Seagate Technology
10323 West Reno (West Dock)
Oklahoma City, OK 73127-9705
P.O. Box 12313
Oklahoma City, OK 73157-2313

10/31/99

John Lohmeyer
T10 Chairman

Subject: Proposal for Fast-160 to be included in SPI-4

Figure 44 - LVD timing measurement points for DT = Fast-160 data transfers

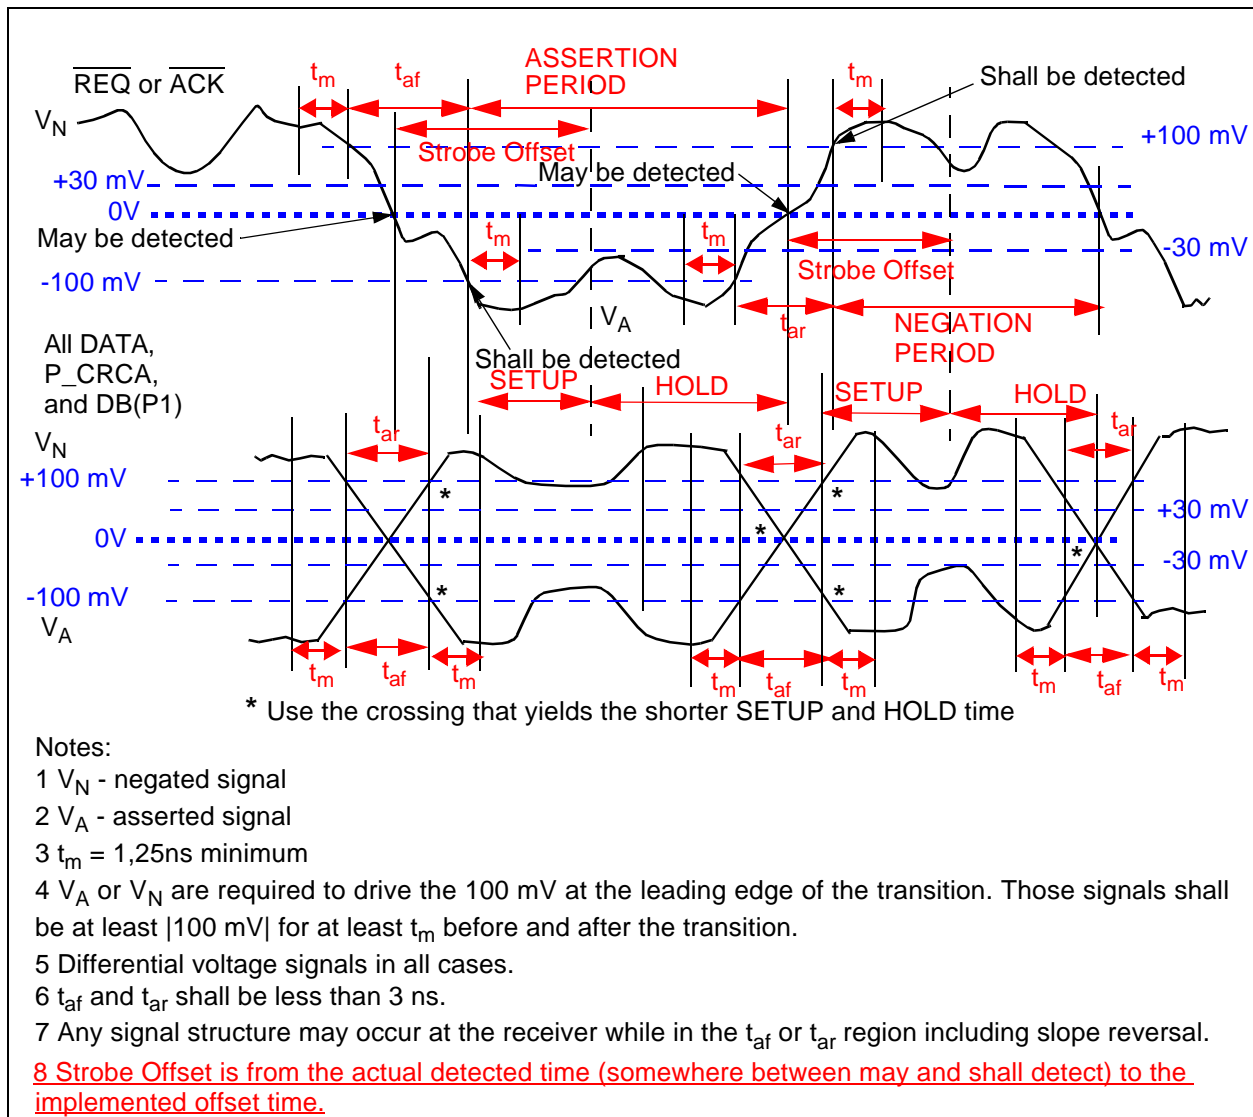
The signal shall transition from -100 to +100 mV or +100 to -100 mV in 0 to 3 ns, the waveform between -100 and +100 mV is not otherwise specified. Signals shall remain above the $|100\text{ mV}|$ level for 1,25 ns at each end of the transition. The signals shall not drop below $|30\text{ mV}|$ except during the transitions. Conditions exist with longer, loaded SCSI busses and irregular REQ and ACK pulse widths where long assertions or negations produce a much larger signal than short assertions or negations. This sets up an environment where the short REQ or ACK pulses may not have adequate timing margin unless the definitions in figure 44 and figure 43 are used in the measurement of timing parameters.

Figure 47 - Fast-160 Training Pattern

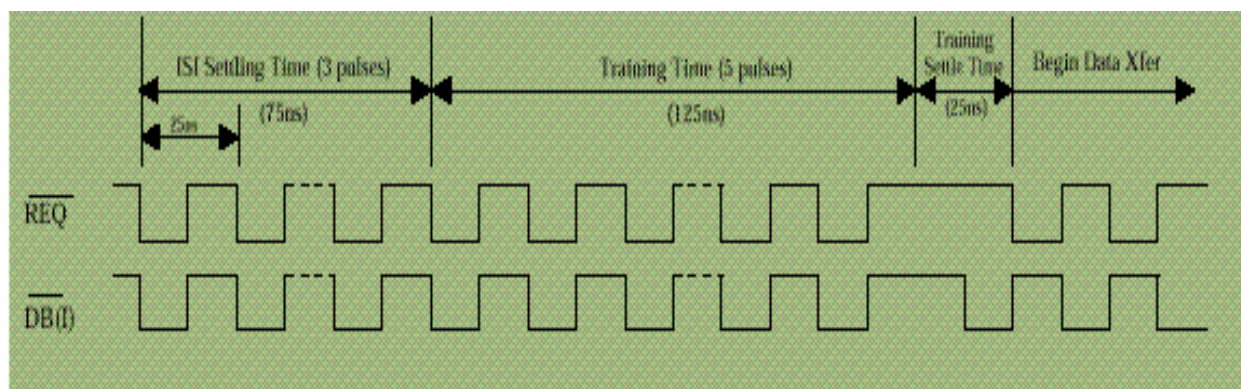
The training pattern for Fast-160 shall be transferred at the start of each Fast-160 data phase. Return ACK/REQ signals from the receiving SCSI device shall be ignored by the originating SCSI device during the training pattern. The training pattern for Fast-160 shall conform to Figure TBD. The receiving SCSI device shall use some or all elements of the training pattern to achieve deskewing. The transmitting device shall not make an intentional shift in relative timing between the databus and the ACK/REQ signal subsequent to the training pattern during the DT data phase. The requirement to not intentionally change relative timing does not include the effects of ISI or ISI compensation.

Figure N.1 illustrates a transmitter drive strength technique.

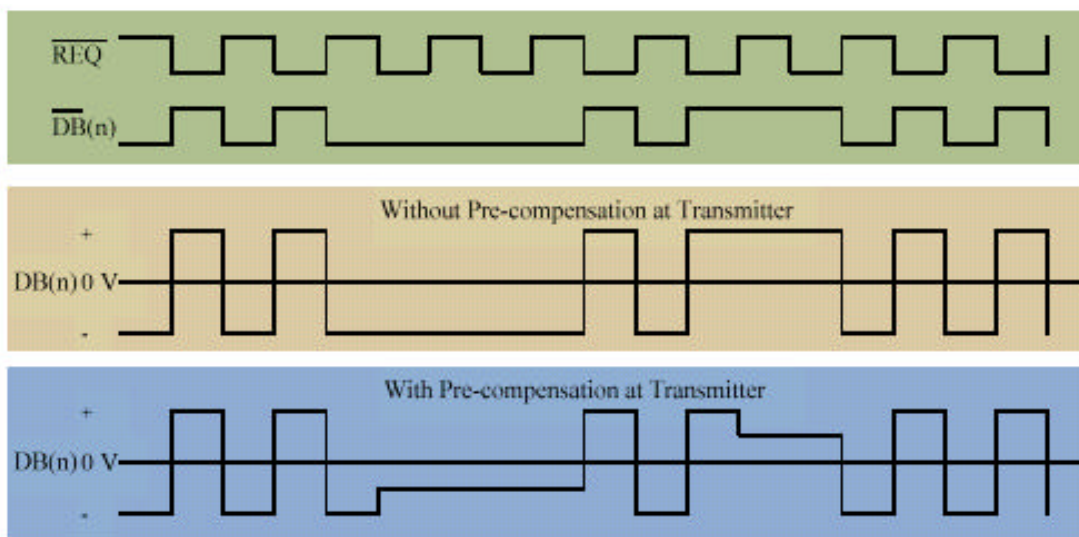
ISI compensation may be achieved by several techniques including time shifting and transmitter drive strength switching. The technique employed is vendor specific but SPI-4 requires that the technique achieves at least a 0,8 ns reduction in ISI at Fast-160.

Figure N.2 Example Deskewing Technique

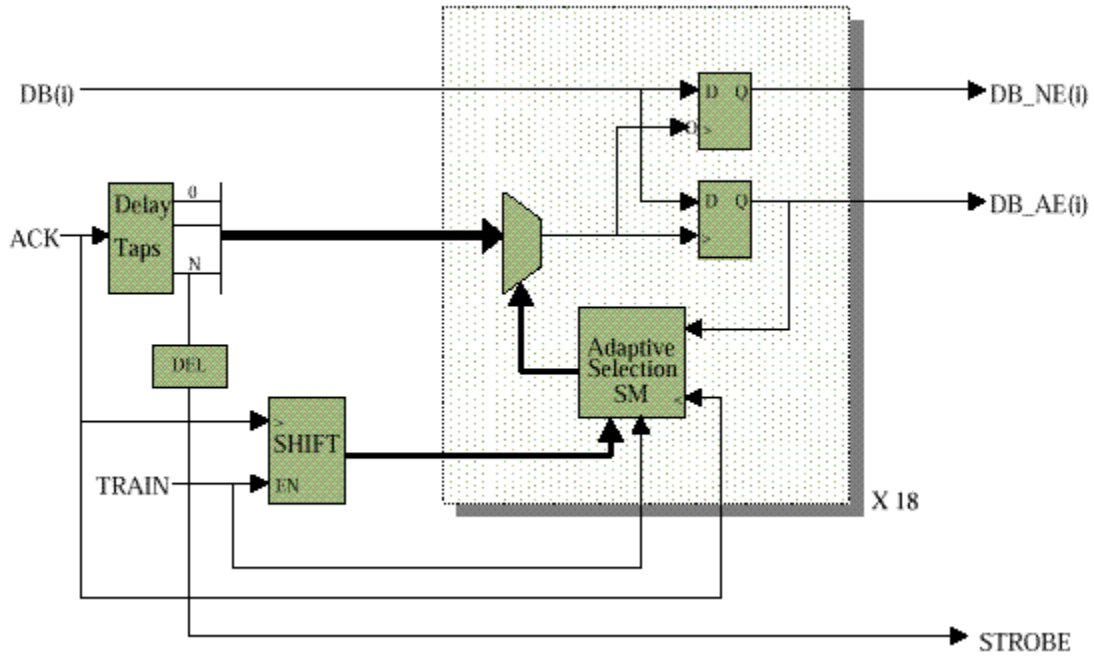
The deskewing technique used in the receiving SCSI device is vendor unique. Any technique that works with the SPI-4 specified training pattern and complies with the specified Receive Skew Compensation timing requirement is allowed. Figure N.2 illustrates such a technique. The training pattern is not available in Fast= \leq 80 and consequently deskewing is only used for Fast $>$ 80.

In this example the tap selection is based upon a binary search algorithm.
